ZONING AND PLATTING COMMISISON SITE PLAN WAIVER REQUEST REVIEW SHEET

CASE NUMBER: SP-2018-0092C PC HEARING DATE: Dec. 4, 2018

PROJECT NAME: The Greens on Cooper Lane

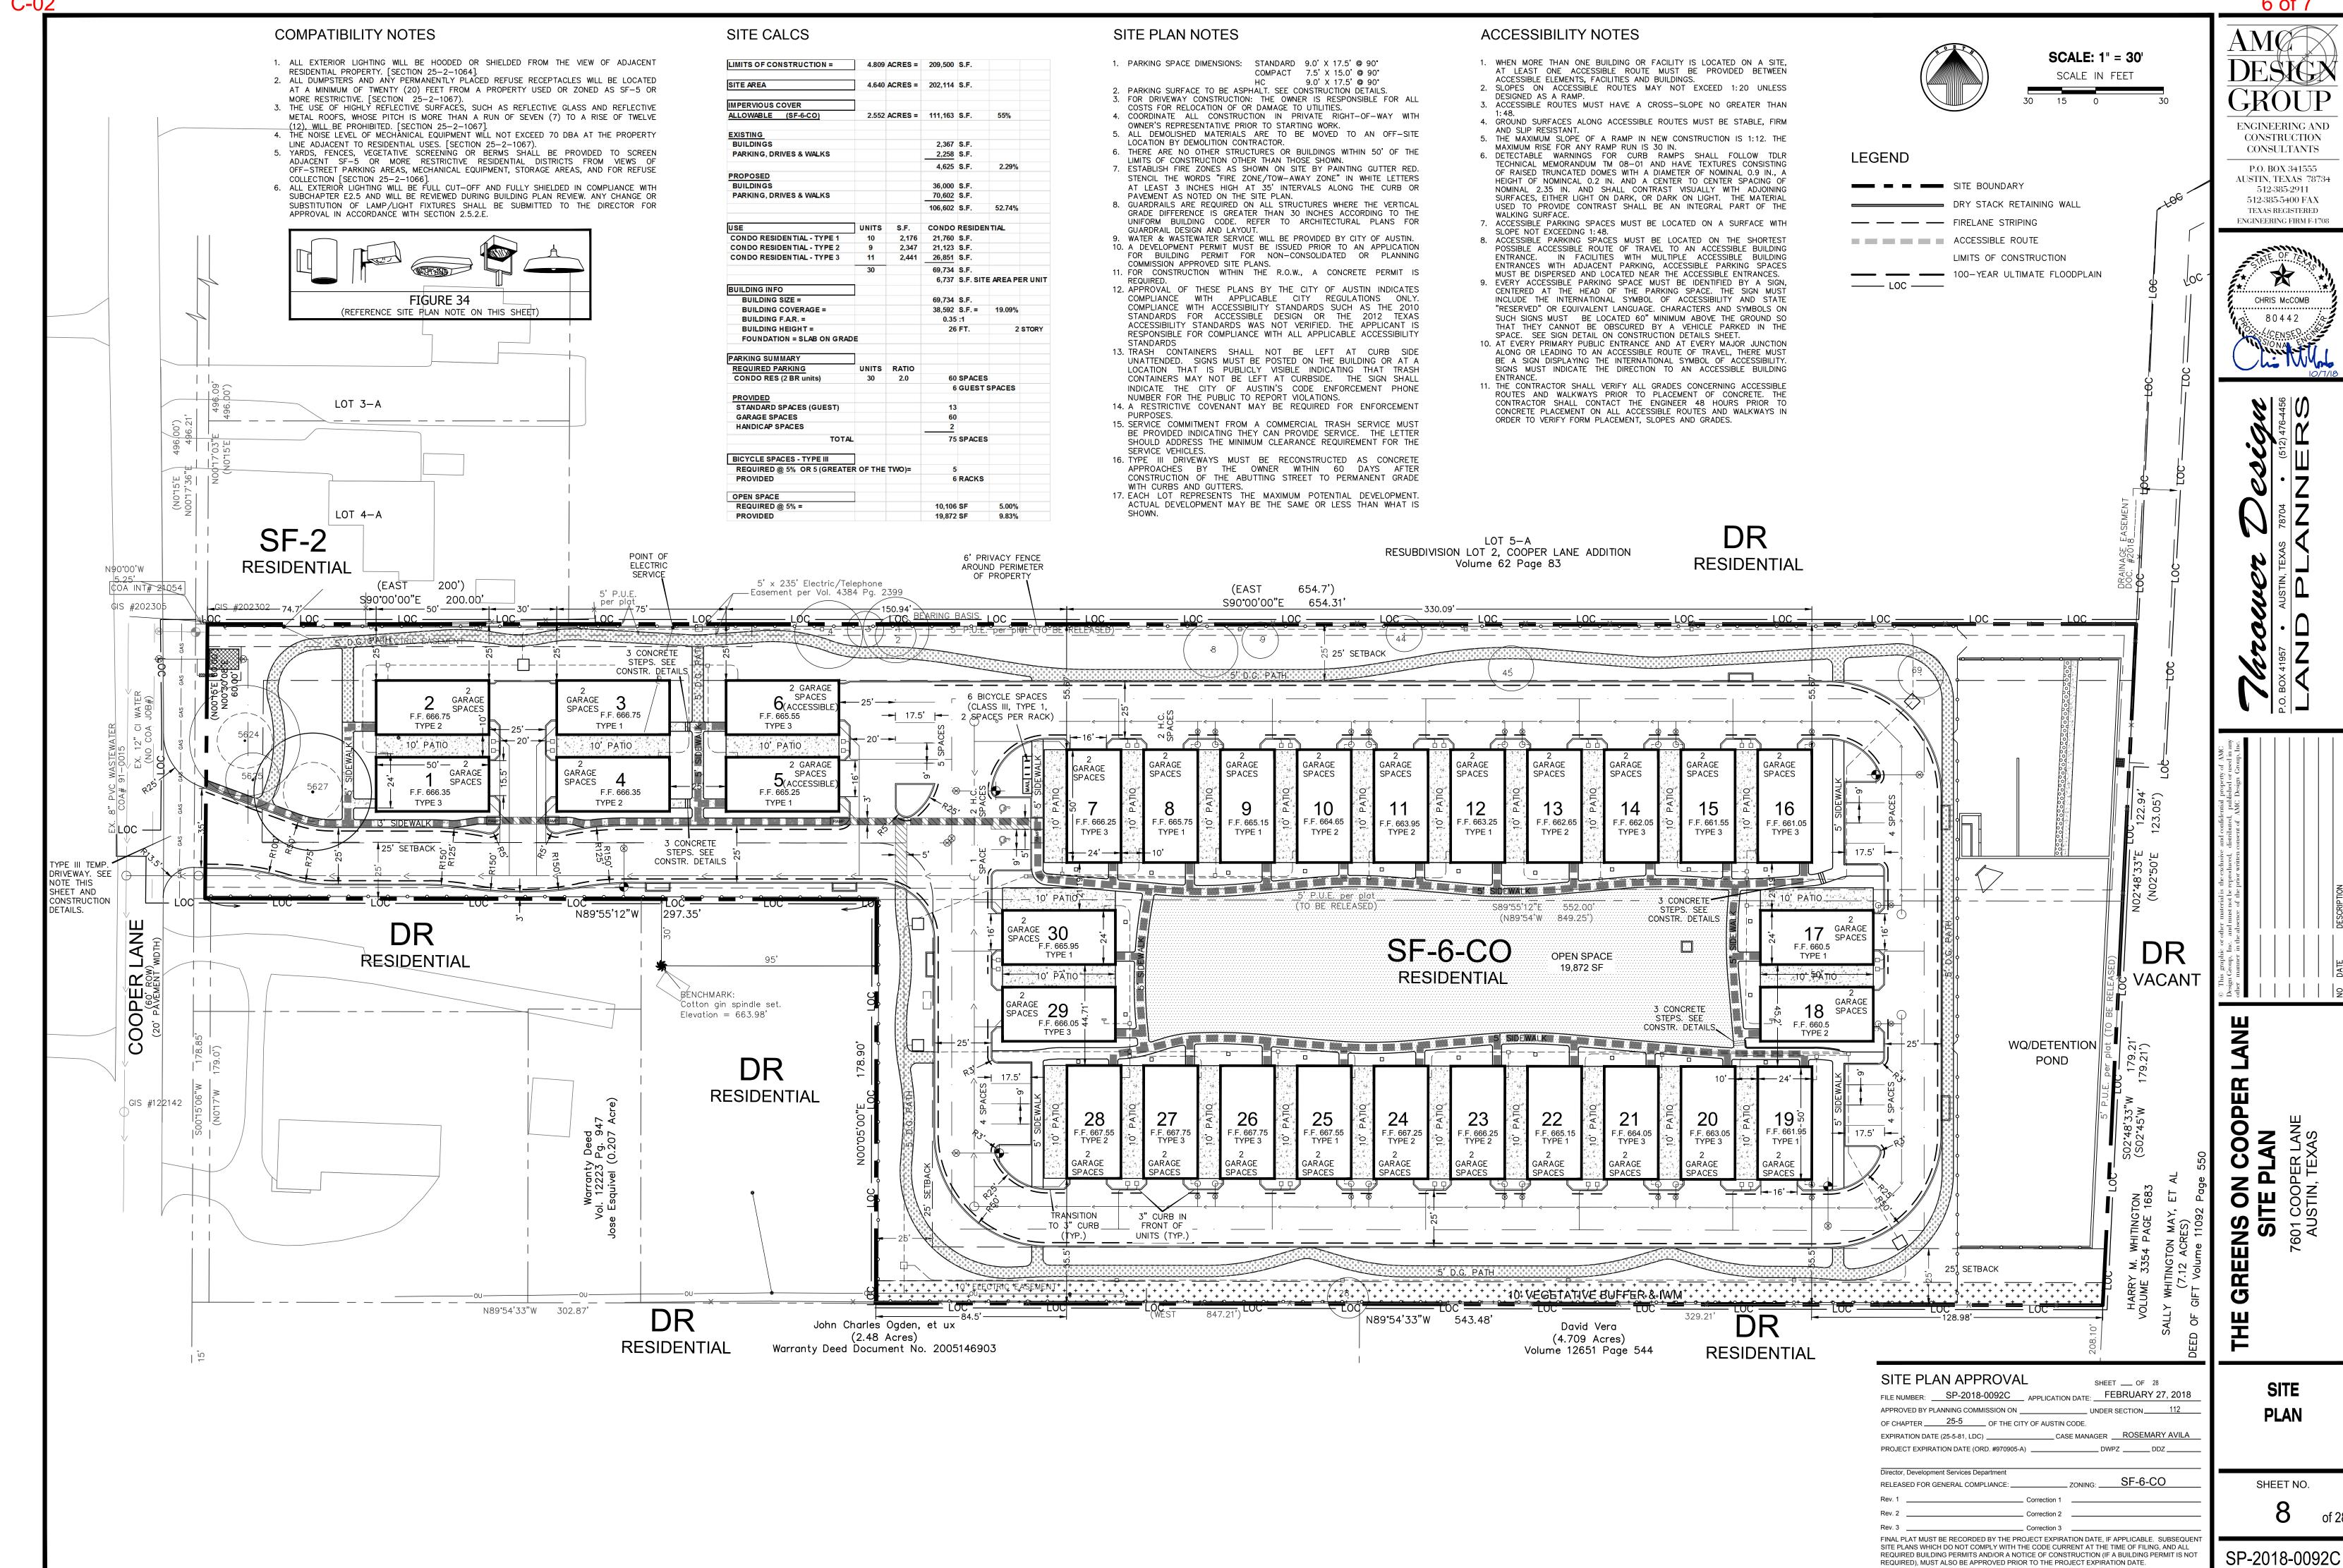
Height of the pond walls is approximately 4'-4.5' at the highest part proximate to the property lines.

Dimensionally, the pond walls are located 5' along the eastern property line with drainage infrastructure

(grate inlet) within 5' of the eastern property line. There is also buried reinforced concrete pipe buried along

that property line as a part of the underground drainage infrastructure. On the north, the pond wall is 15'

from the northern property line. Strict compliance to the compatibility standards is a 25' setback.

We respectfully request positive consideration for a waiver to Compatibility Standards section 25-2-

1063(B) to allow for a structure within 5' of the east property line and 15' on the north property line the

pond wall setbacks based on the above findings and conditions.
